RAI 03.07.02-24, Supplement 1, Revision 1**QUESTION:****Follow-up Question to RAI 03.07.02-15 (STP-NRC-100036)**

RAI 03.08.01-9, Revision 2**QUESTION:****Follow-up to Question 03.08.01-6**

RAI 03.08.04-17, Supplement 1**QUESTION:****Follow-up to Question 03.08.04-1 (RAI 2964)**

RAI 03.08.04-28, Revision 1**QUESTION:****Follow-up to Question 03.08.04-19**

Figure 3H.6-41: Dynamic At-Rest Lateral Earth Pressure (Excluding SSI and SSSI Seismic Soil Pressures) on the East, West, and North Walls of Pump House

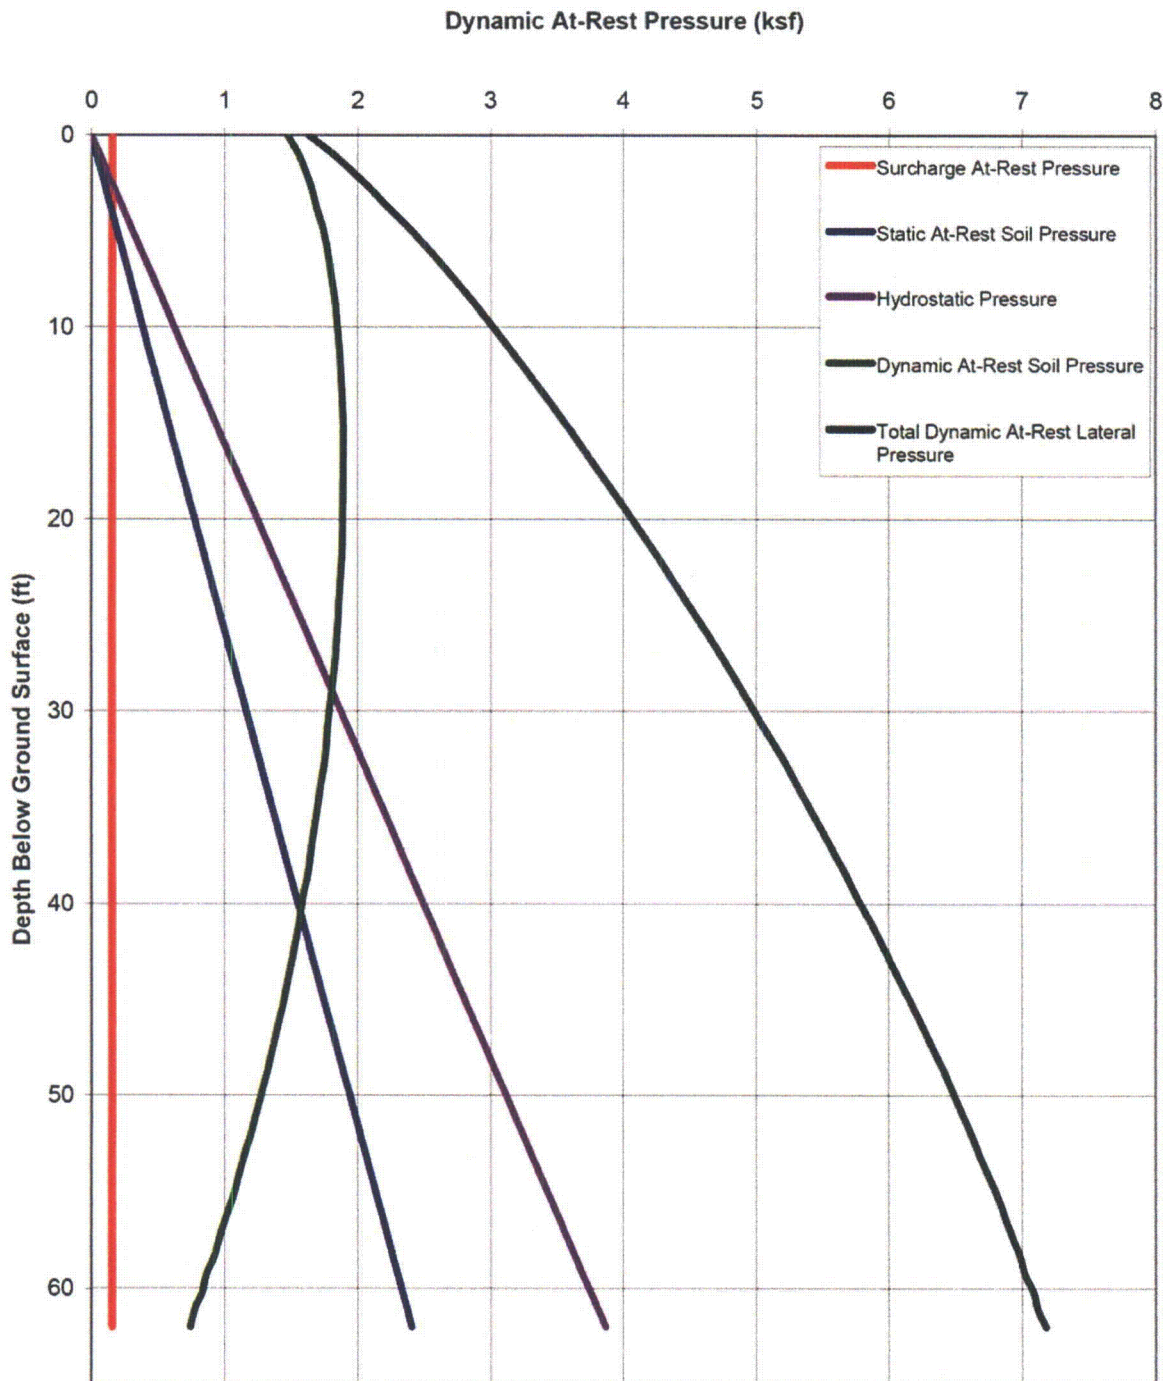
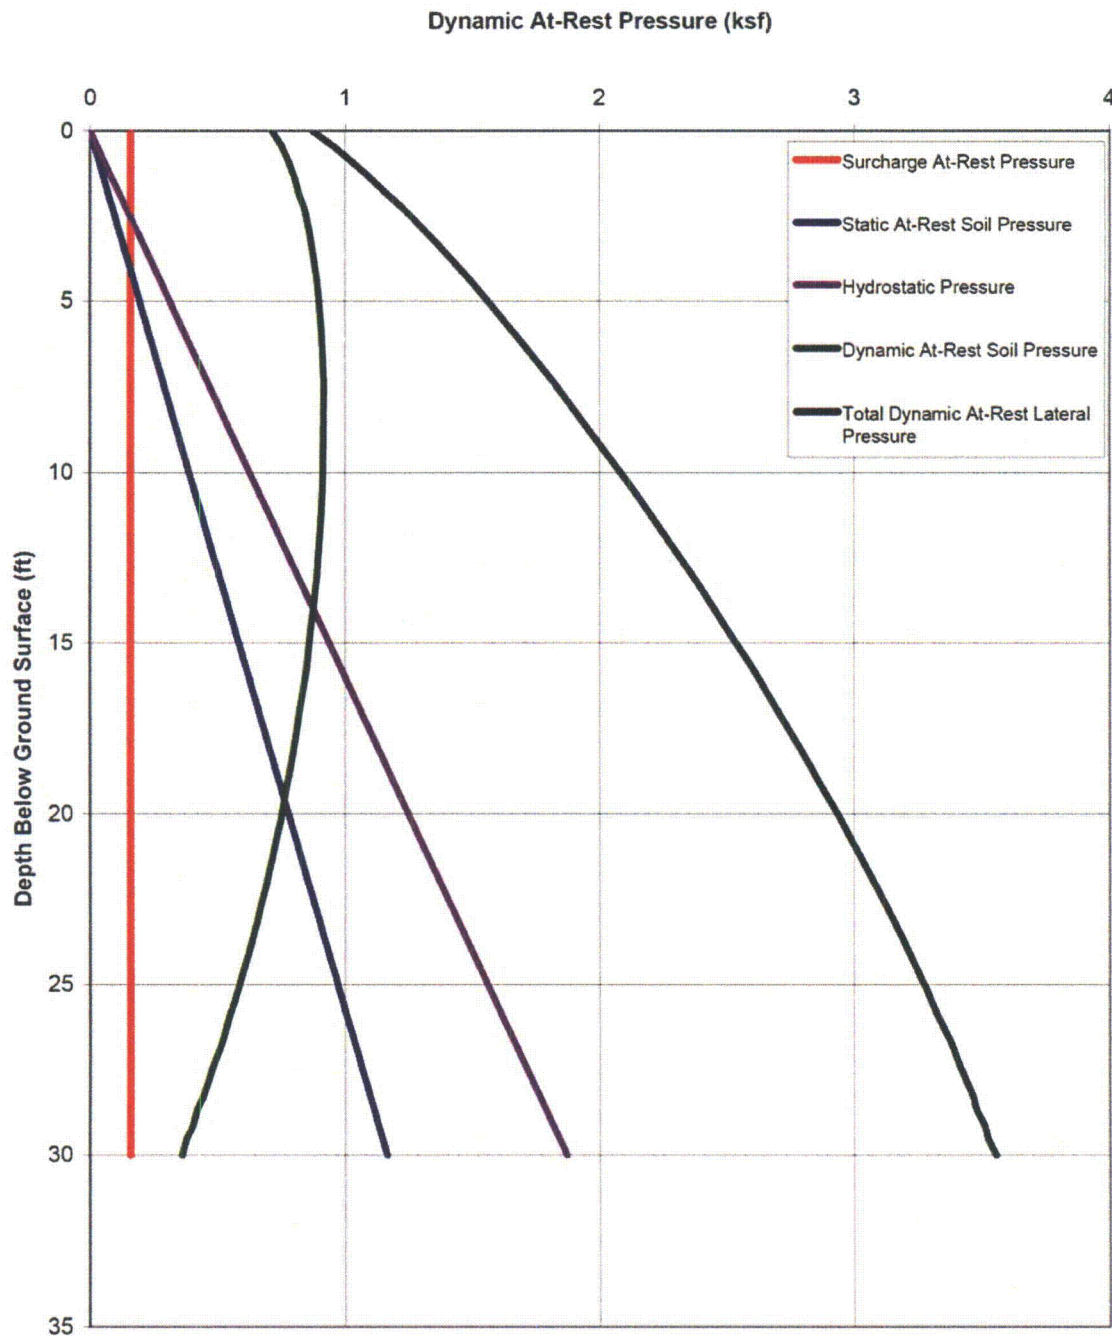
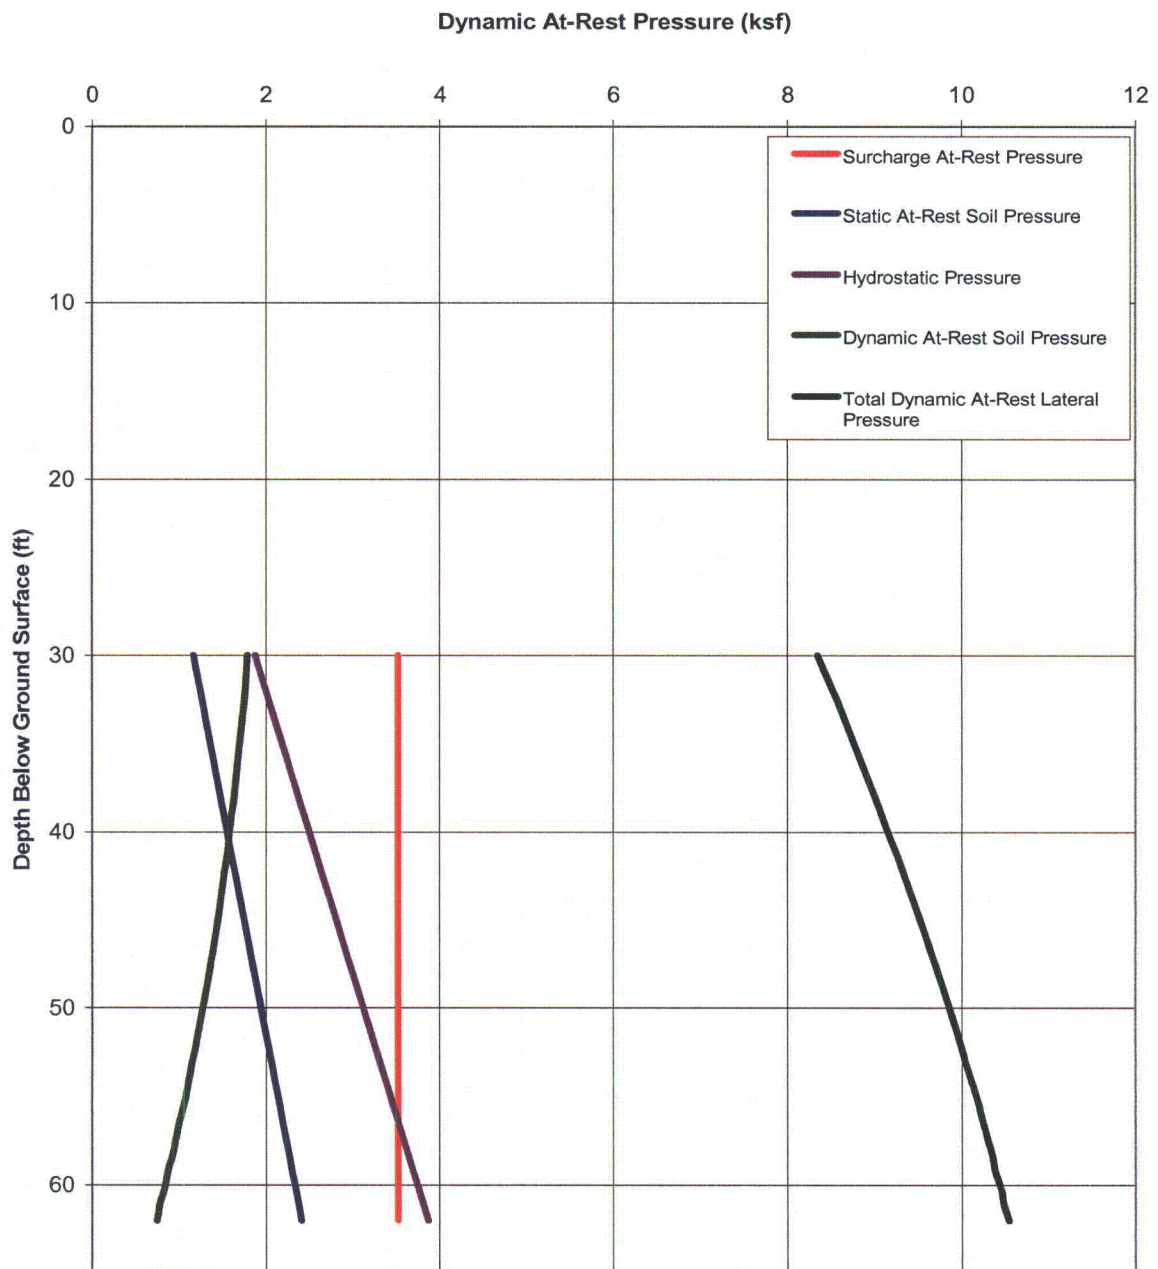
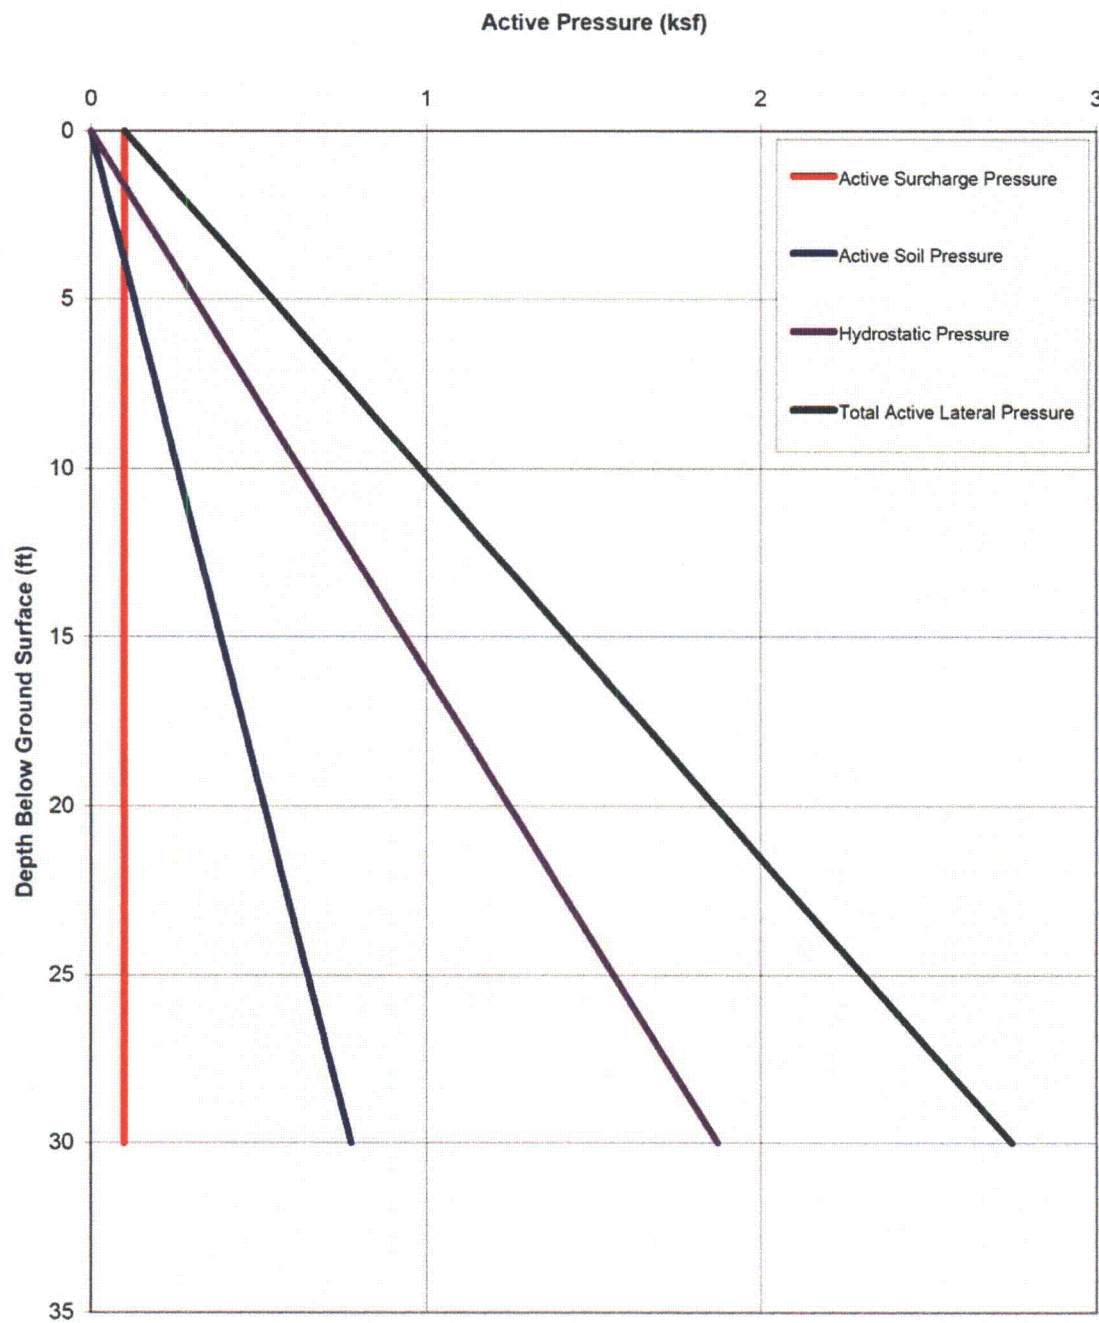
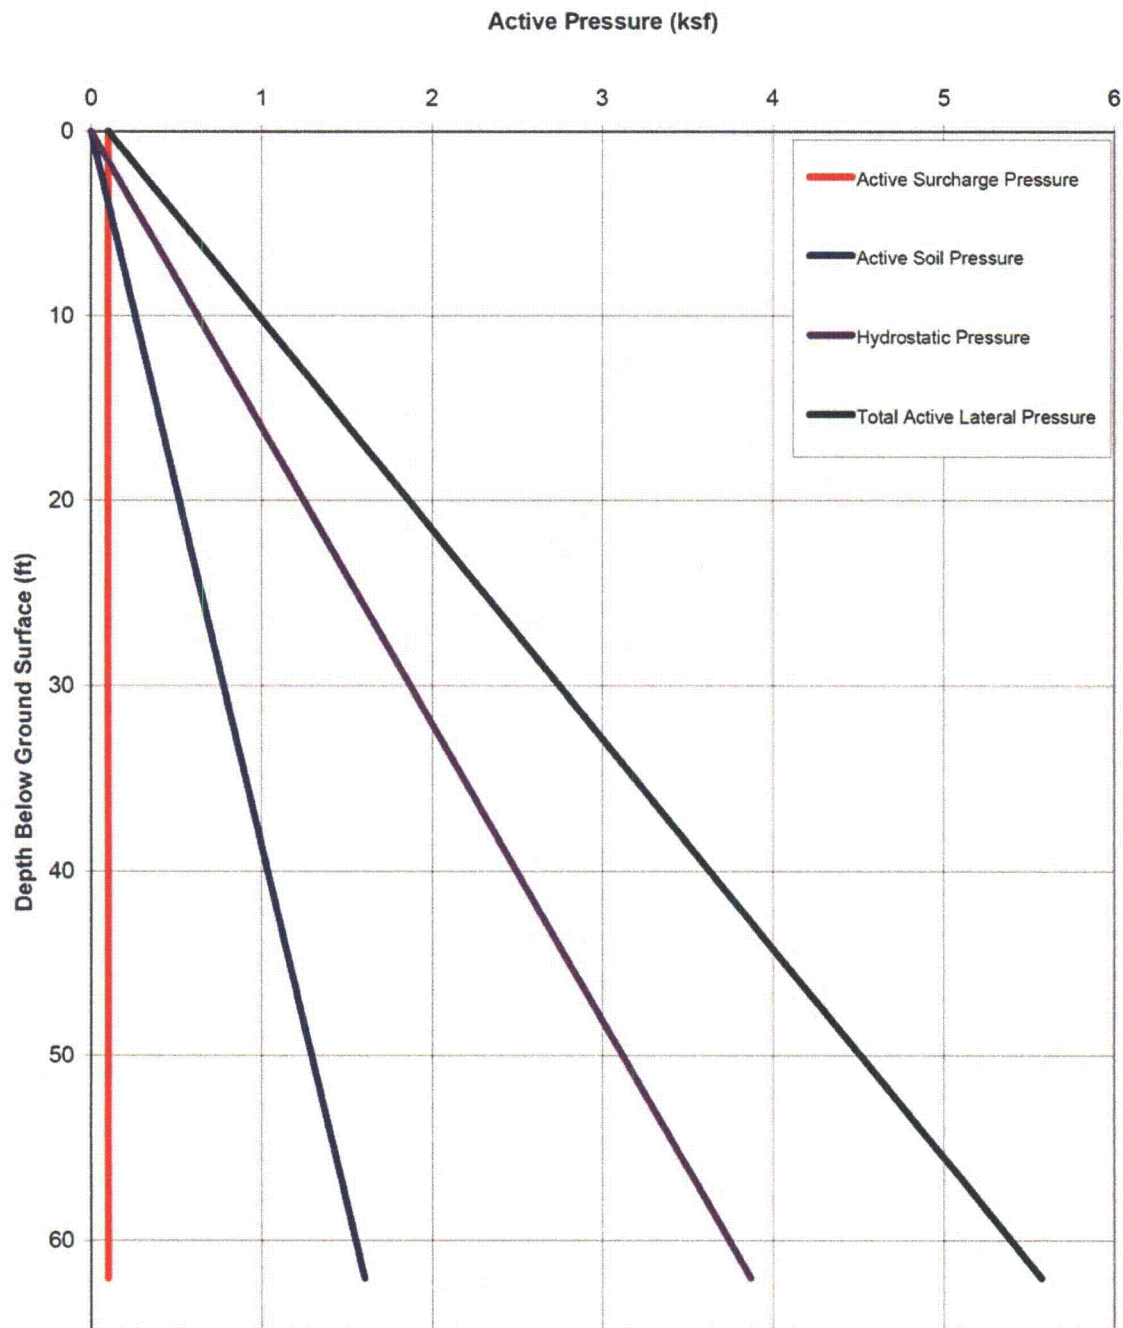
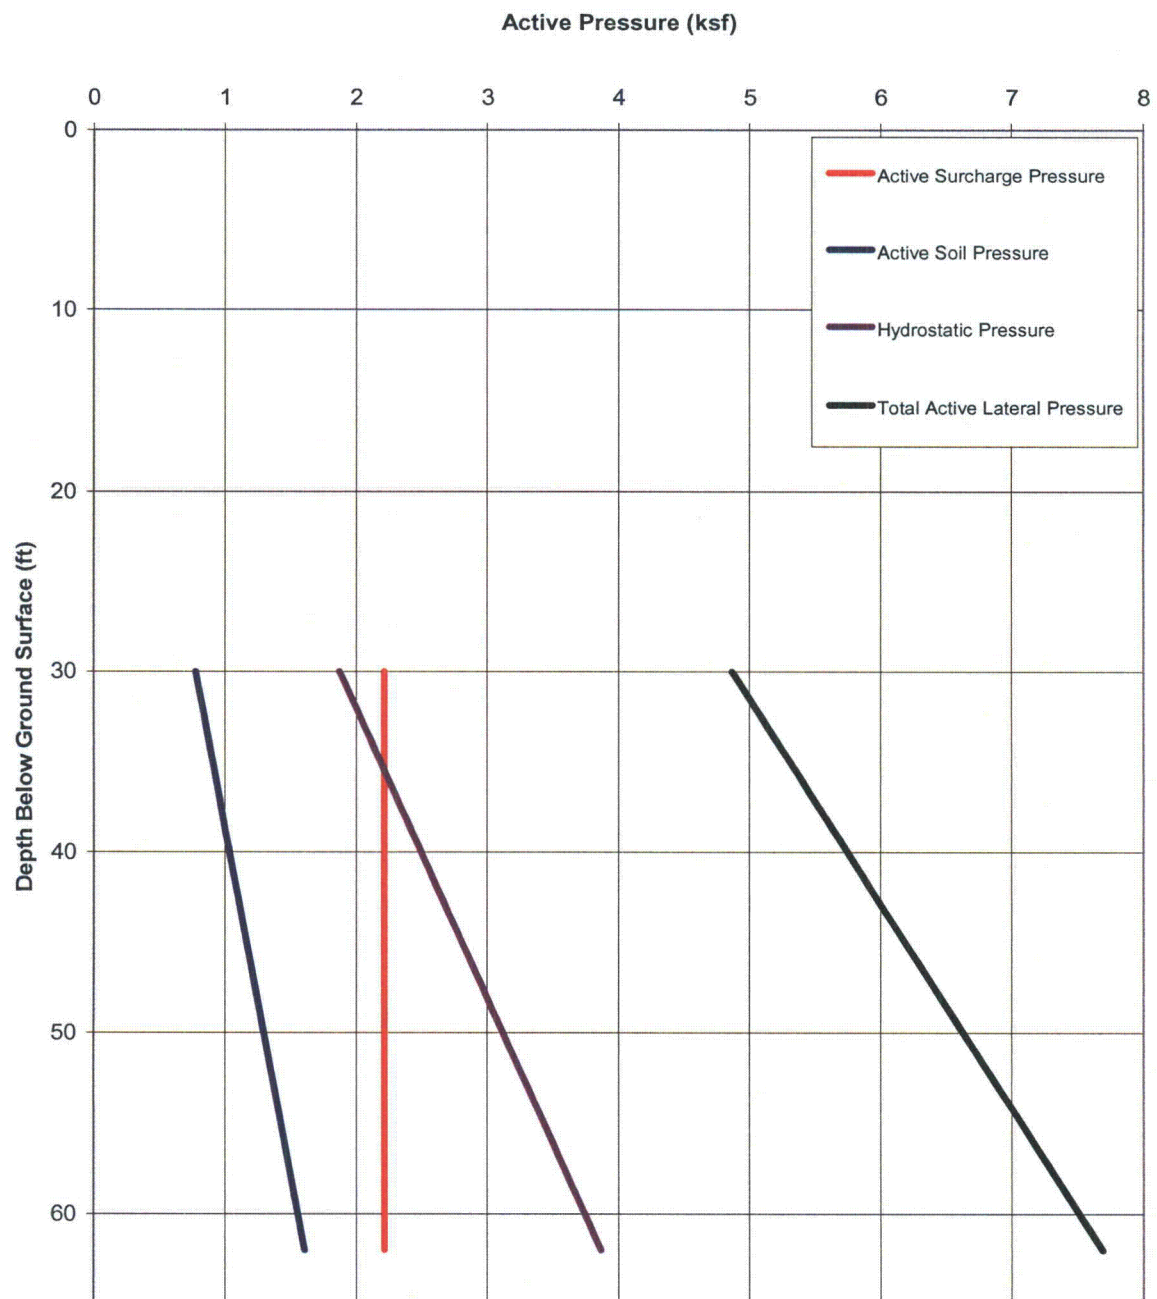
- b) For the staff to conclude that the design of structures with deep foundations, such as the Reactor Building (RB) and Control Building (CB), is satisfactory for the site, the site-specific design loads are needed to compare with the design loads used for the DCD. Lateral soil pressure is one such load. Therefore, please provide the lateral soil pressures for the RB and the CB, and compare these calculated pressures with those used in the ABWR standard plant design. Please also confirm if the effects of adjacent structures are considered in computing the lateral soil pressures, and if not, provide the justification for not doing so.

The SSSI incremental seismic soil pressure curves for the Ultimate Heat Sink (UHS) and RSW Pump House will be provided in response to RAI 03.07.02-22, currently scheduled to be submitted by March 15, 2011. The at-rest, dynamic at-rest, active, and passive soil pressure profiles are provided in Figures 3H.6-41 through 3H.6-43 and 3H.6-232 through 3H.6-240, included in Enclosure 1 of this response.
